## A4AF3/A4BF2 PRELIMINARY INFORMATION

Since model year 2000 Hyundai has been using a new transaxle in the Accent, Elantra, and Tiburon. It is the A4AF3 for use with 1.5L engines, and the A4BF2 for use with 2.0L engines. These transaxles are almost identical to the A4AF1 and A4AF2 with several major exceptions. The A4AF1 and A4AF2, as well as the new A4AF3 and A4BF2 are almost identical to the KM series except that they are “backwards.”

# Technical Service Information

Figure 1

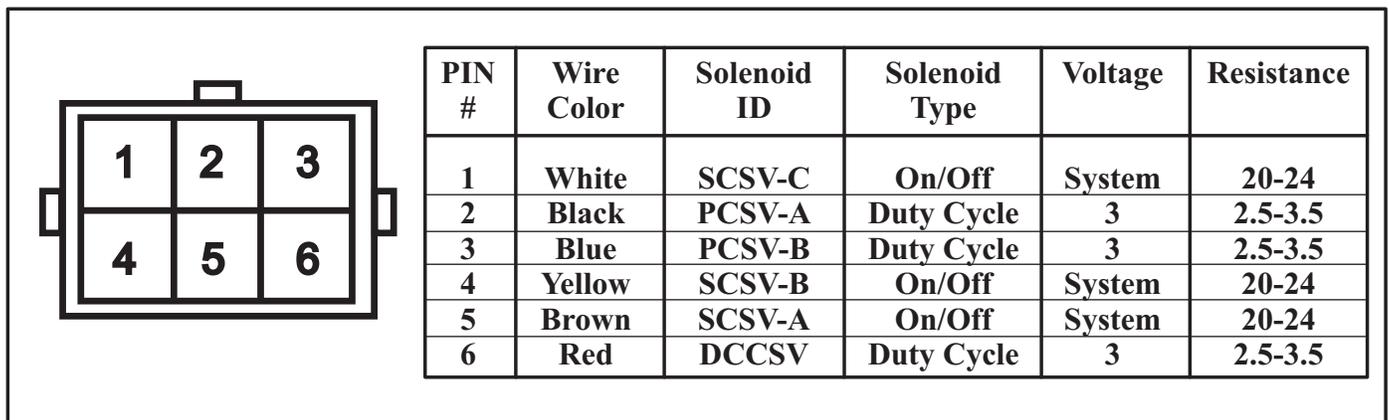
In addition to the code changes, changes were also made to the pinouts to accommodate the two new wires. The case connector is now six pins (See Figure 1). The computer appears identical to a fourth generation KM computer, but the pin assignments have changed (see Figure 2).

Figure 4

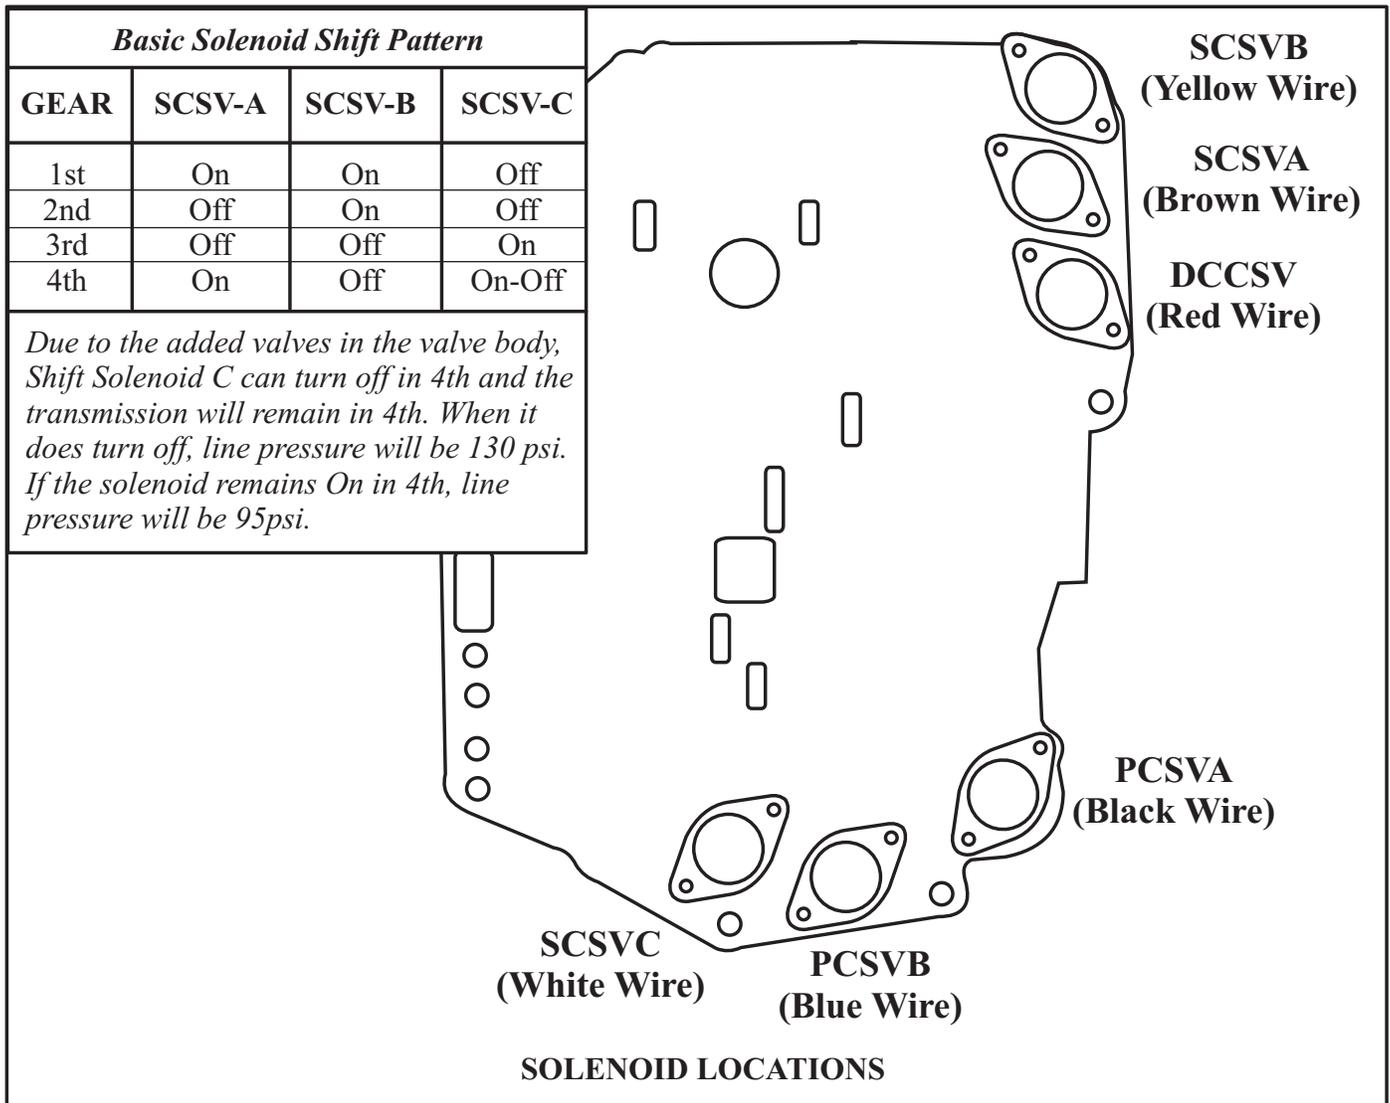
The big change is the addition of two solenoids, Pressure Control Solenoid B (PCSVB) and Shift Control Solenoid Valve C (SCSVC) as seen in figure 4, a couple of valves (Figure 6), and an accumulator for the Forward (Rear) clutch (Figure 7). Pressure Control Solenoid Valve A (PCSVA) as in previous applications is the solenoid that controls main line pressure. PCSVB directly controls the application of the Forward (Rear Clutch) on a 4-3 downshift. When this solenoid fails you can expect to see harsh 4-3 downshifts. The other new solenoid is Shift Control Solenoid Valve C (SCSVC) controls the end clutch apply and reduces line pressure in 4th gear for less drag on the engine increasing fuel economy. The new valves in the valve body are only to support the new solenoid scheme. They are the Fail Safe Valve, the Control Switch Valve, and the High-Low Pressure Valve (Figure 6). The check balls remain the same as other KM style units (Figure 7).

Figure 5

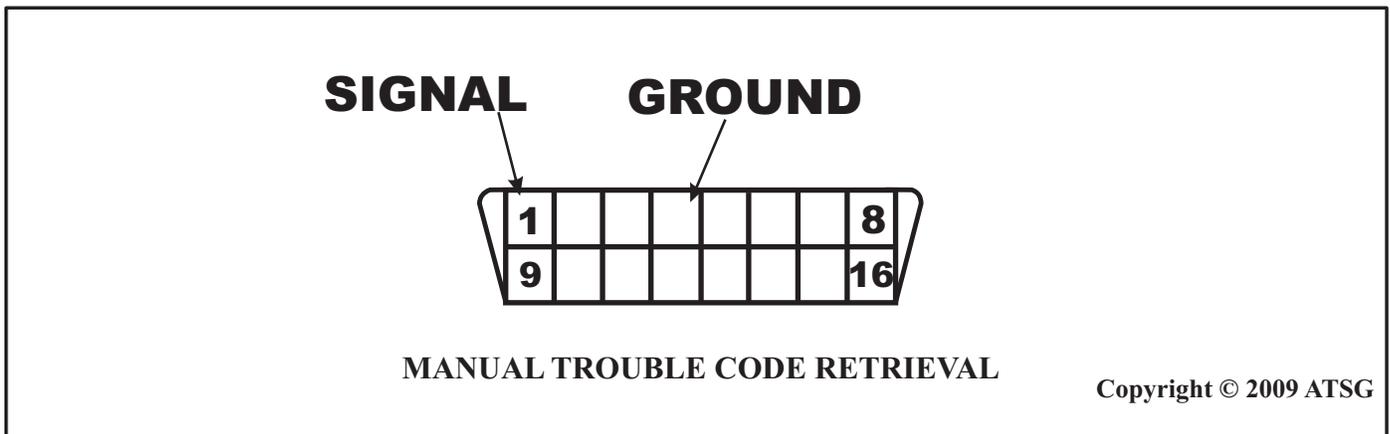
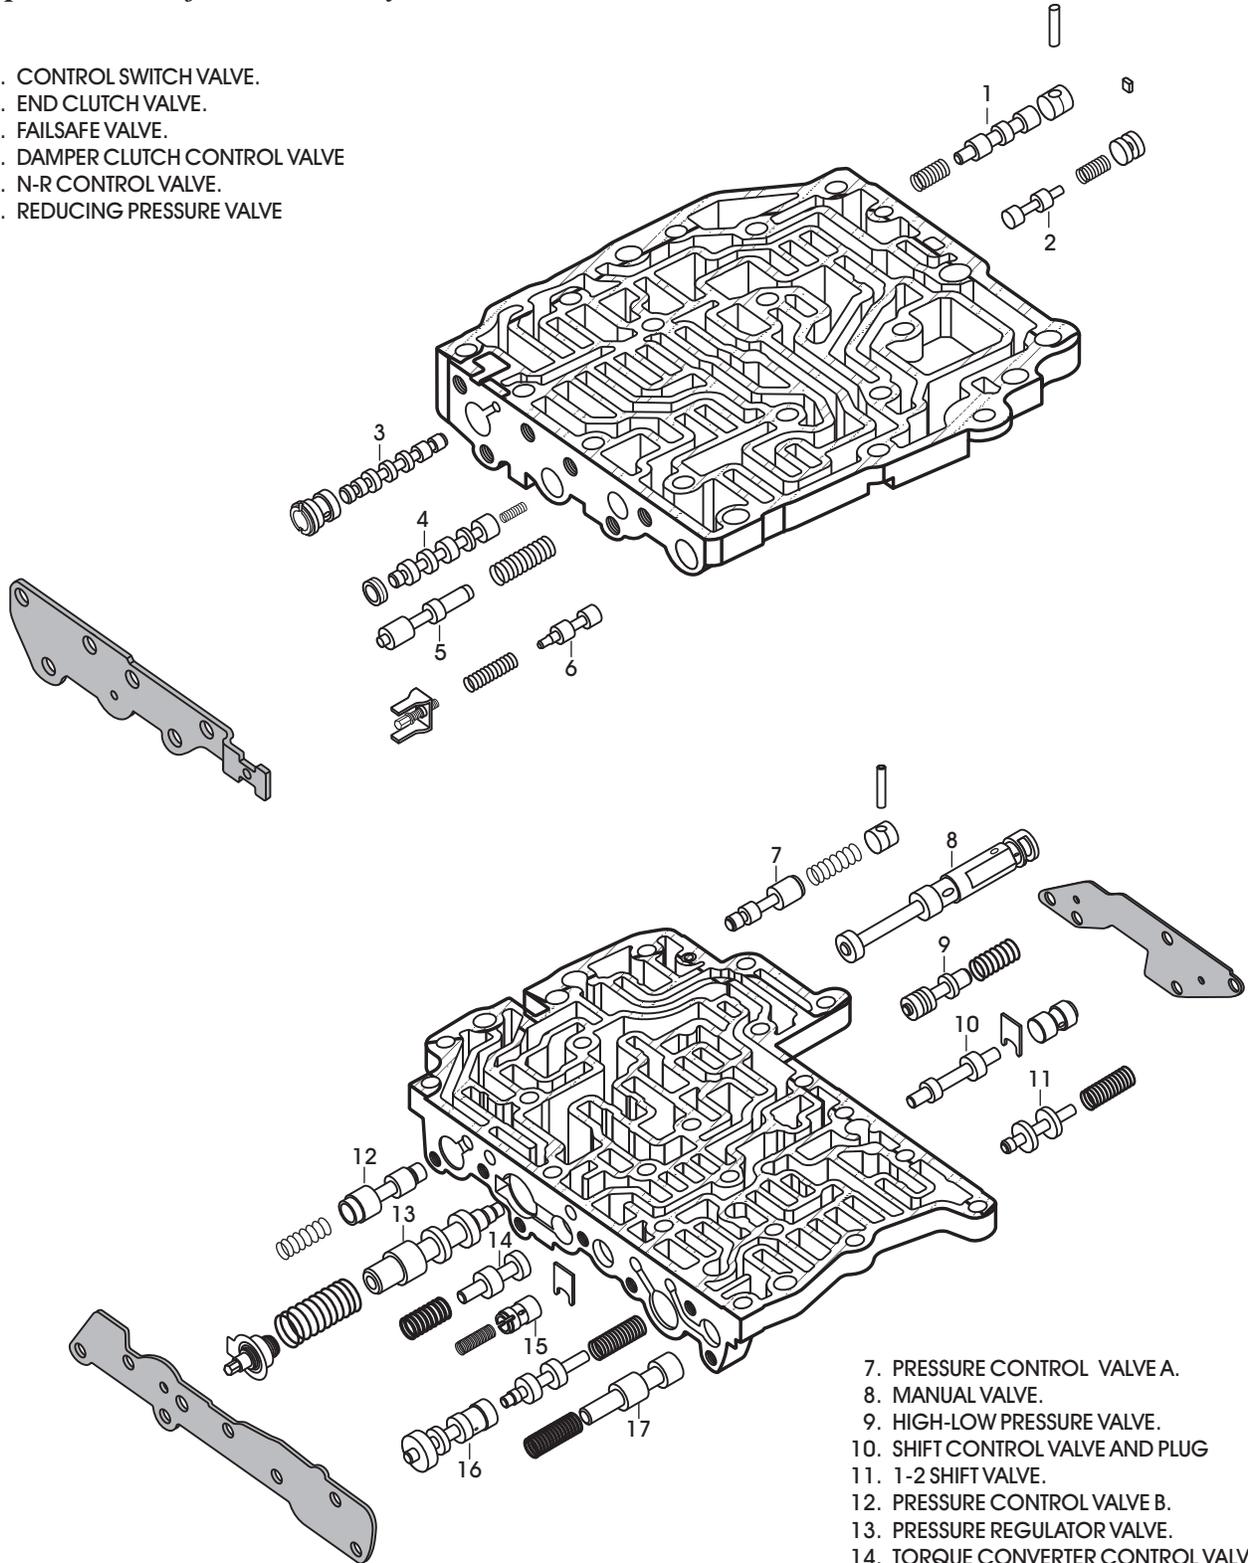
With the addition of the new solenoids comes changes to the Diagnostic Trouble Codes. Although not as generalized as a code P1750 (Solenoid Pack Fault), the new codes do not specify if a solenoid circuit is open or shorted. It does specify which solenoid though. P0760 indicates a fault in the SCSC solenoid circuit, and P0765 is for the PCSB. Both will cause the MIL to light and a failsafe condition. See Figure 3 for a complete code list. The pin on the diagnostic connector used to manually retrieve codes with an analog voltmeter has moved to pin 1 (see Figure 5).
